2.0 APPROVED CONTENTS

2.3 Decay Heat Limits (Changes in blue are due to RAI response)

Figure 2.1-3
MPC-32ML Cell Identification

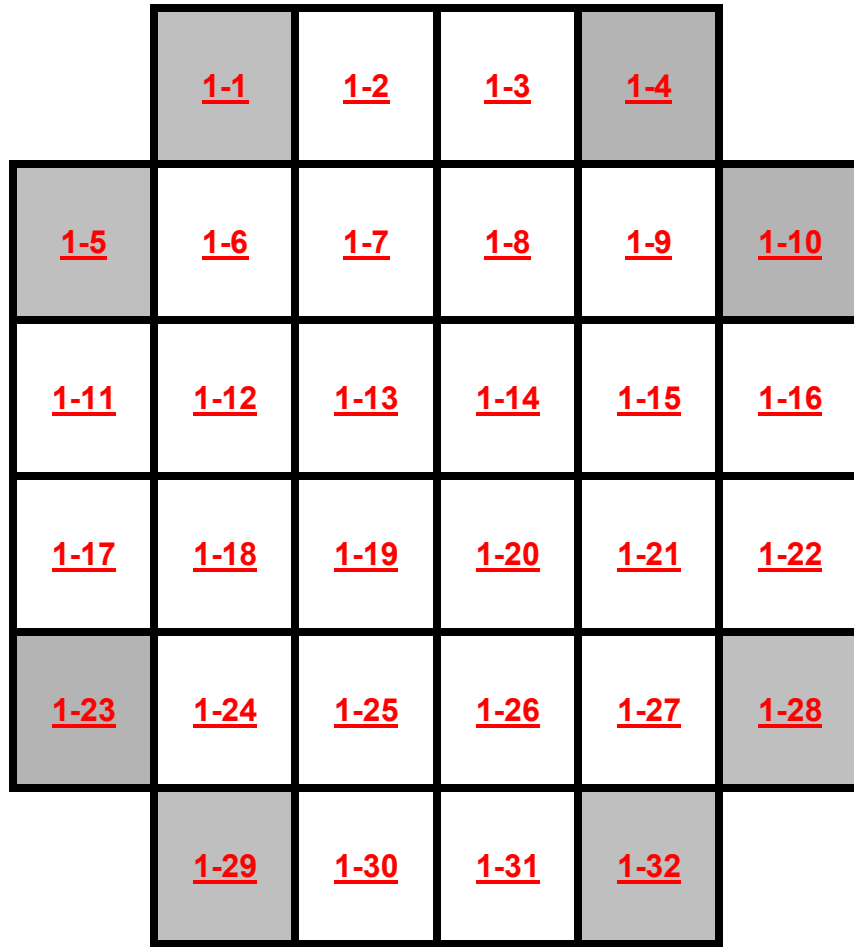
B. Quantity per MPC: 32 FUEL ASSEMBLIES with up to eight (8) DAMAGED FUEL ASSEMBLIES or FUEL DEBRIS in DAMAGED FUEL CONTAINERS (DFCs). DFCs may be stored in fuel storage locations 1-1, 1-4, 1-5, 1-10, 1-23, 1-28, 1-29, and 1-32 (see Figure 2.1-3). The remaining fuel storage locations may be filled with PWR UNDAMAGED FUEL ASSEMBLIES meeting the applicable specifications.

Note 1: Fuel assemblies containing BPRAs, TPDs, WABAs, water displacement guide tube plugs, orifice rod assemblies, or vibration suppressor inserts, with or without ITTRs, may be stored in any fuel storage location. Fuel assemblies containing APSRs, RCCAs, CEAs, CRAs, or NSAs may only be loaded in fuel cells 1-6 through 1-9, 1-12 through 1-15, 1-18 through 1-21, and 1-24 through 1-27.

Figure 2.1-4
MPC-31C Cell Identification

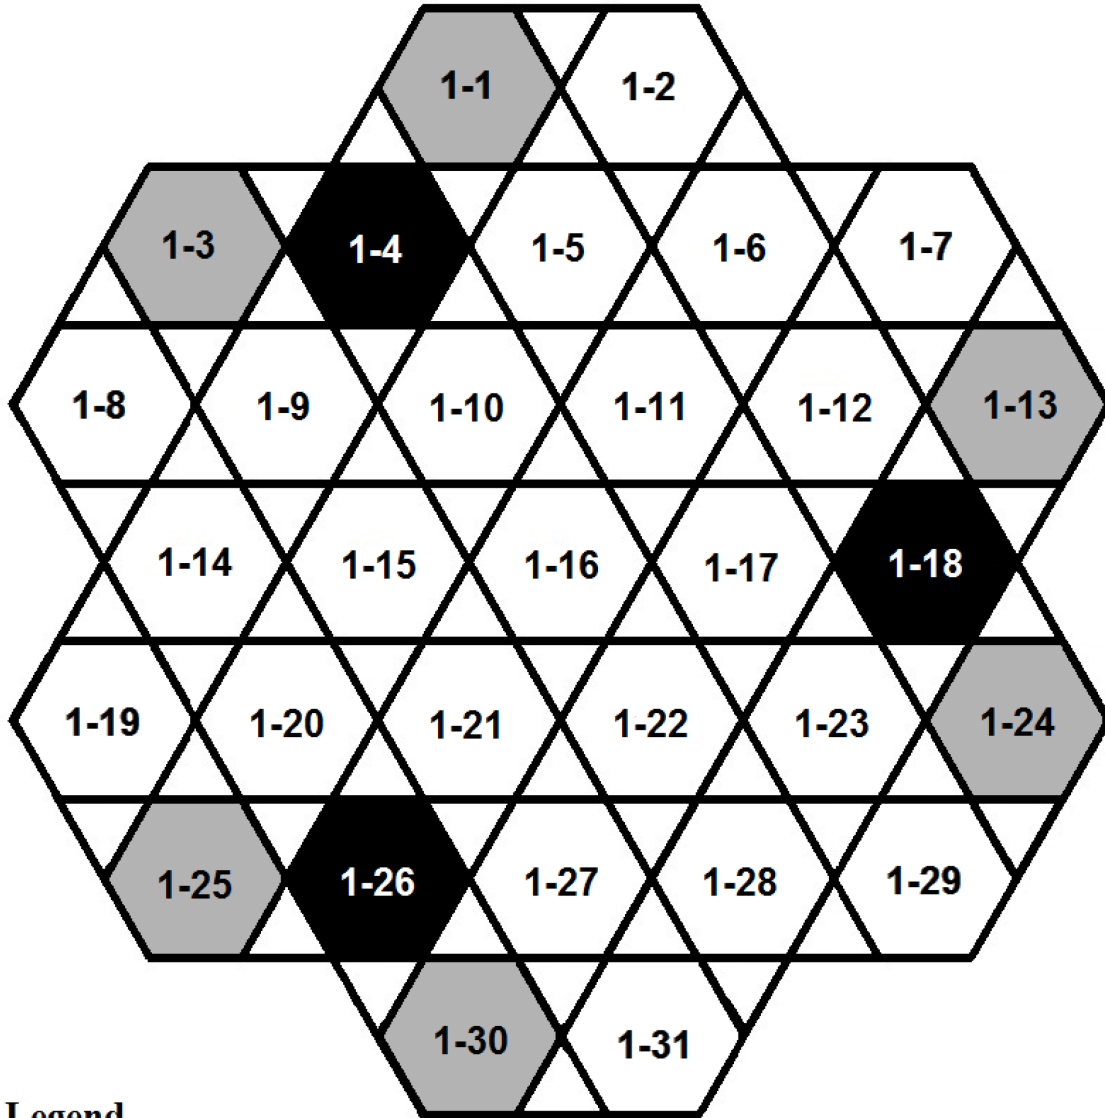
B. Quantity per MPC: 31 FUEL ASSEMBLIES with up to six (6) DAMAGED FUEL ASSEMBLIES in DAMAGED FUEL CONTAINERS (DFCs). DFCs may be stored in fuel storage locations 1-1, 1-3, 1-13, 1-24, 1-25, and 1-30 (see Figure 2.1-4). The remaining fuel storage locations may be filled with PWR UNDAMAGED FUEL ASSEMBLIES meeting the applicable specifications.

Quantity per MPC: 31 FUEL ASSEMBLIES with up to six (6) DAMAGED FUEL OR FUEL DEBRIS in DFCs. DFCs may be stored in fuel storage locations 1-1, 1-3, 1-13, 1-24, 1-25, and 1-30 (see Figure 2.1-4). If a DFC is stored in cells 1-1 or 1-3, cell 1-4 must be empty, if a DFC is stored in cells 1-13 or 1-24, cell 1-18 must be empty, if a DFC is stored in cells 1-25 or 1-30, cell 1-26 must be empty. The remaining fuel storage locations may be filled with PWR UNDAMAGED FUEL ASSEMBLIES meeting the applicable specifications.

Note 1: Fuel assemblies containing BPRAs may be stored in any fuel storage location. Fuel assemblies containing NSAs may only be loaded in fuel cells 1-10, 1-11, 1-15, 1-16, 1-17, 1-21, or 1-22.
